Permit to Alter Case Report

Filing Date: September 17, 2015
Case No.: **2015-000878PTA**
Project Address: **300 GRANT AVENUE/272 SUTTER STREET**
Conservation District: Kearny-Mason-Market-Sutter Conservation District
Zoning: C-3-R (Downtown Retail) District
80-130-F Height and Bulk District
Block/Lot: 0287/013, 014
Owner : Grant Avenue Properties LLC
C/O St. Bride's Managers LLC Attn: John Loehr
Two Stamford Landing, Suite 115
69 Southfield Avenue
Stamford, CT 06902
Project Contact: Steve Atkinson, Arent Fox LLP
55 2nd Street, Ste. 2100
San Francisco, CA 94105
Staff Contact: Marcelle Boudreaux - (415) 575-9140
Marcelle.boudreaux@sfgov.org
Reviewed By Tim Frye- (415) 575-6822
Tim.frye@sfgov.org

RE: **Meeting Notes from Review and Comment at the
August 17, 2016 ARC-HPC Hearing for the
300 Grant Avenue project**

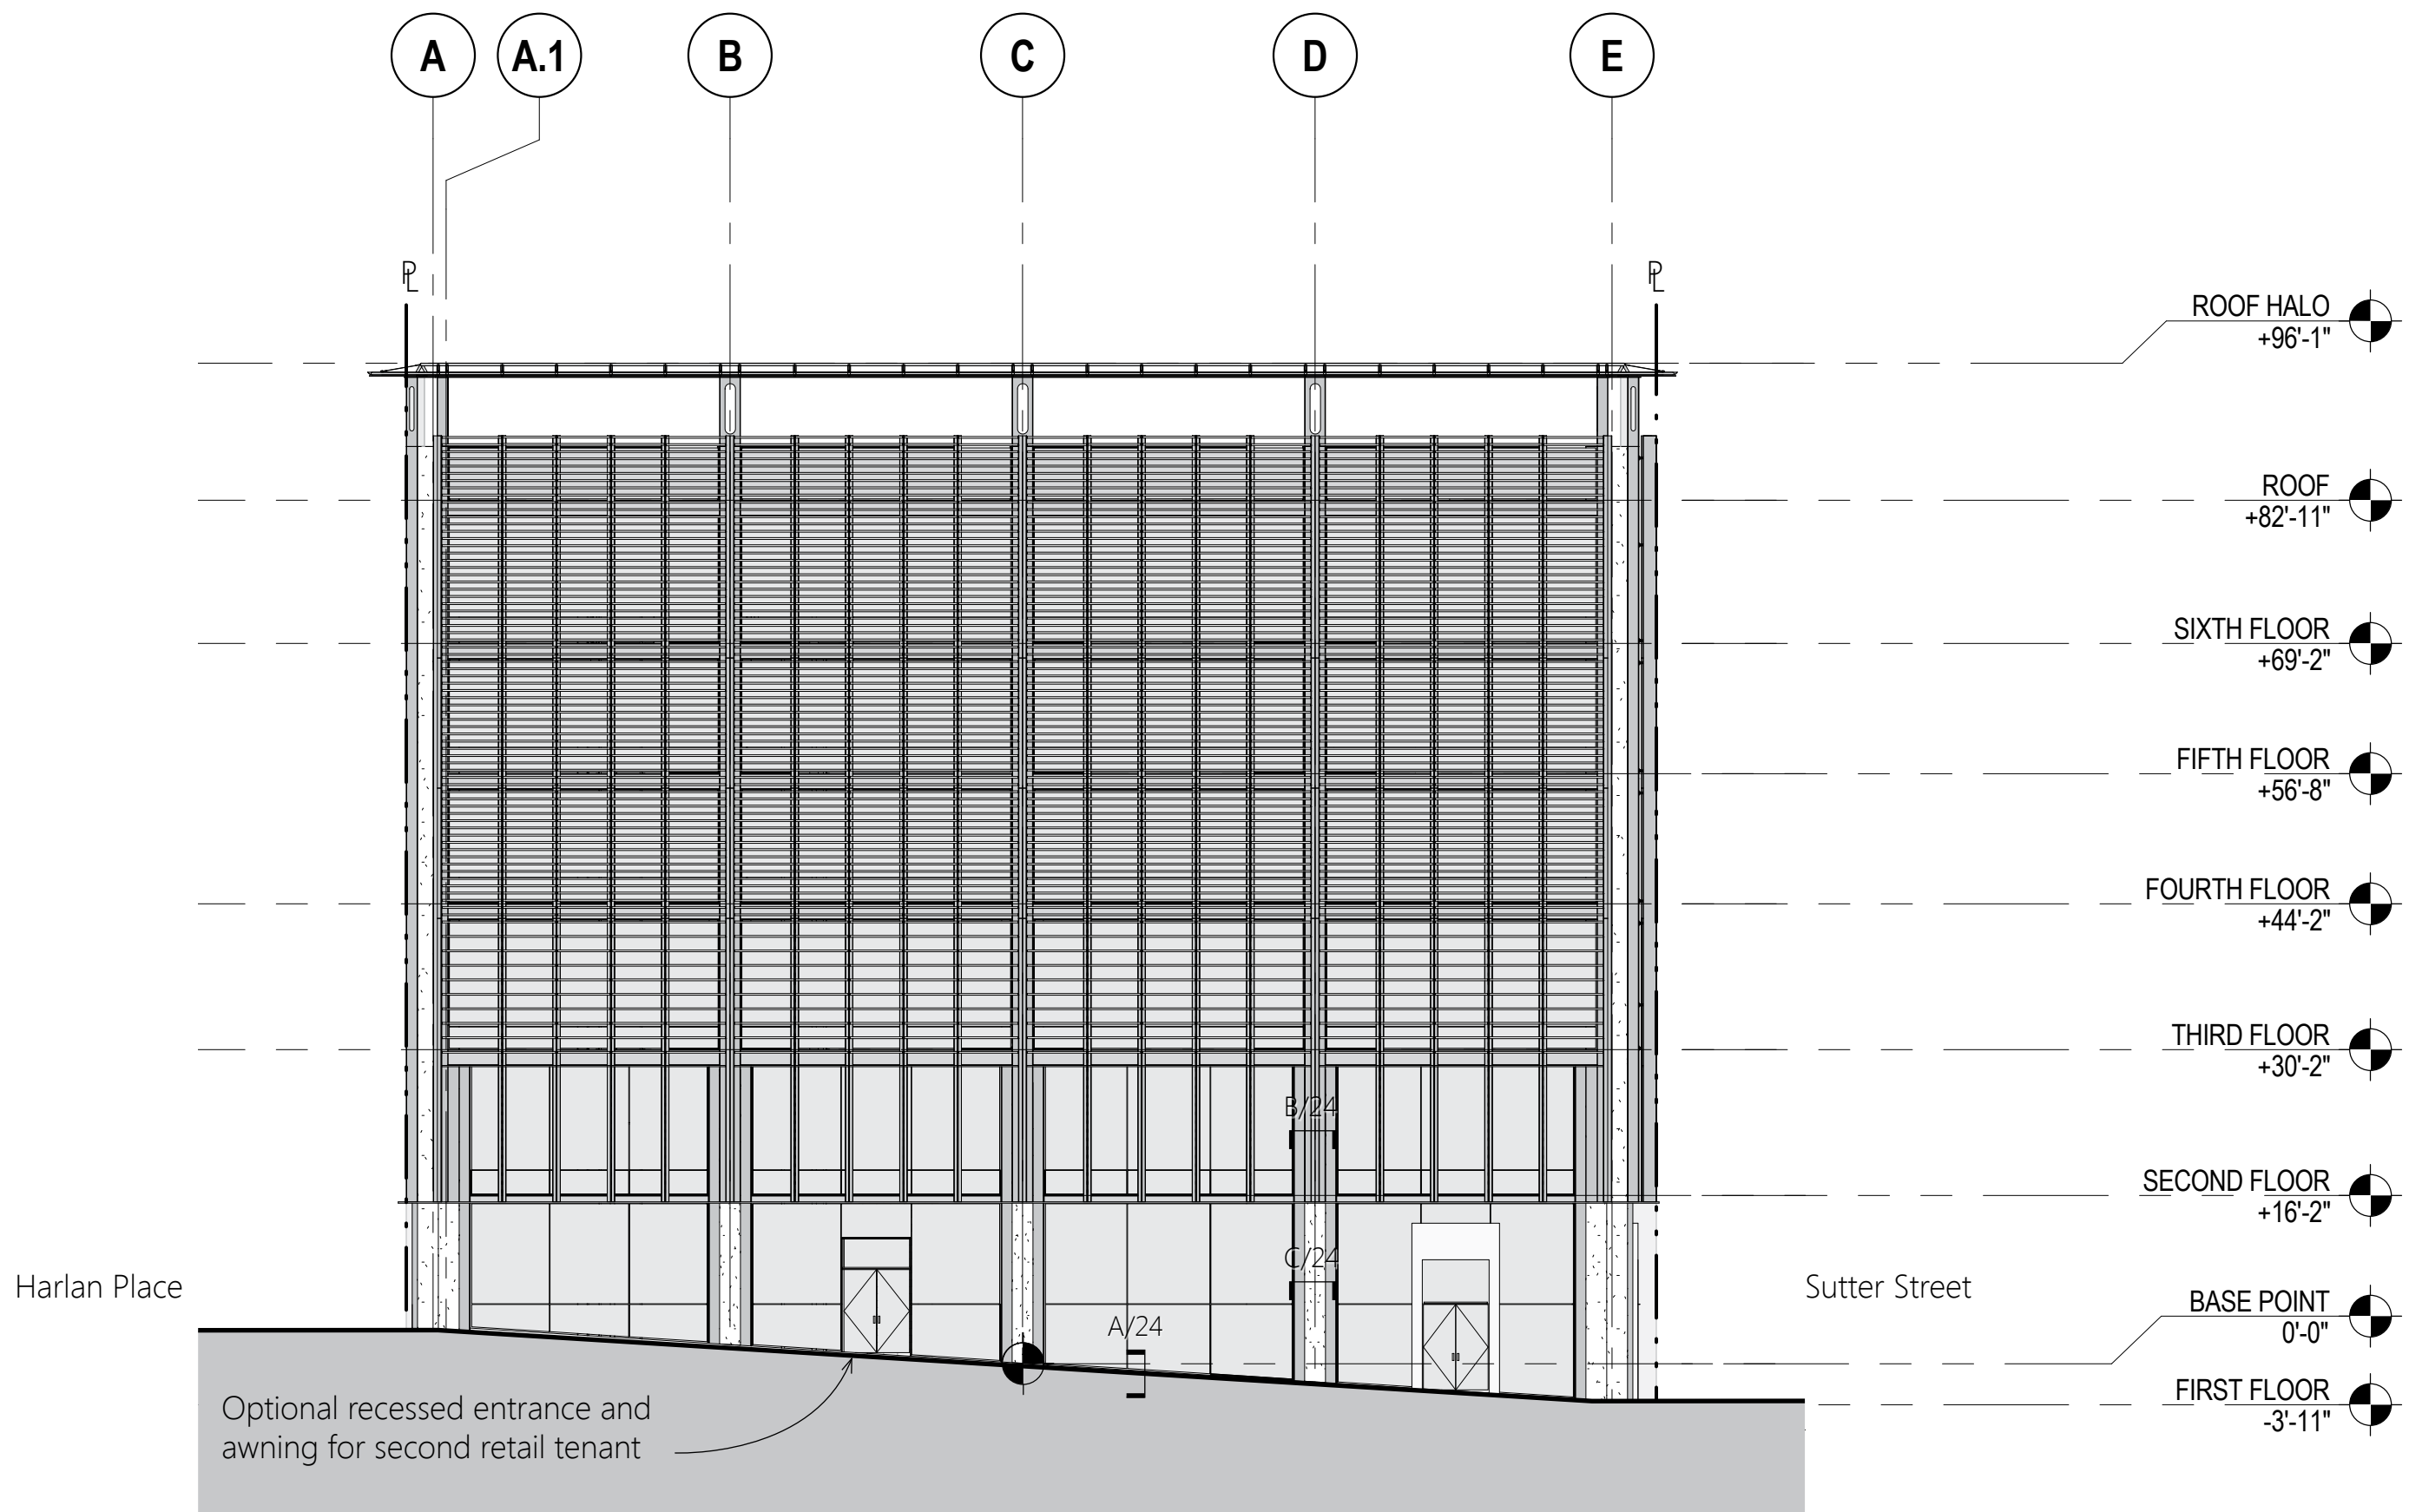
- The north elevation on Harlan Place (alley), primarily composed of a glazed curtain wall at the retail and office uses, is not compatible with the District due to the inconsistent solid-to-void ratio and materials selection. At ARC, the Commissioners recommended continuing the exterior terra cotta scrim around to clad the first bay (westernmost bay) of the north elevation. Continuing the scrim will continue the design intent and the building will read as more compatible with the Massing and Composition consistent with the District. Corrugated metal is inconsistent with the Materials and Colors characteristic of the District.

- (2) The Project Sponsor shall incorporate the design input per the Architectural Review Committee to continue the terra cotta scrim to the westernmost bay of the north façade.

2. **Terra Cotta Scrim.** The Project Sponsor shall incorporate the Architectural Review Committee design input to continue the architectural terra cotta screen ("scrim") to the westernmost bay on the north façade.

I am writing in response to one of the comments in the Meeting Notes from Review and Comment at the August 17, 2016 ARC-HPC Hearing for the 300 Grant Avenue project, dated August 29, 2016 and the proposed condition of approval to require that scrim be added to the Harlan frontage. The relevant excerpt is below:

The primary function of the ceramic scrim is to provide passive solar shading for the building. The north elevation (Harlan Place) receives no direct sunlight which is why a scrim is not provided on that side of the building. Also, the scrim on the Sutter and Grant facades helps reinforce the horizontal tripartite building order (base, shaft and capital). Continuing the exterior ceramic scrim around to clad the first bay (westernmost bay) of the north elevation would have the opposite effect by creating three *vertical* façade sections (loading area, glass curtain wall and ceramic scrim) and compromising the integrity of the building order that is prevalent in this district. Finally, adding a scrim on the north elevation would require substantial redesign to keep it behind the property line, resulting in a loss of leasable floor area, re-modulation of the entire curtain wall and structural column systems along Grant Avenue and redesign of the HVAC system within the building.

Therefore, based on the reasons cited above, we respectfully request that you delete the proposed condition to continue the exterior ceramic scrim around to clad the first bay (westernmost bay) of the north elevation a condition of approval.
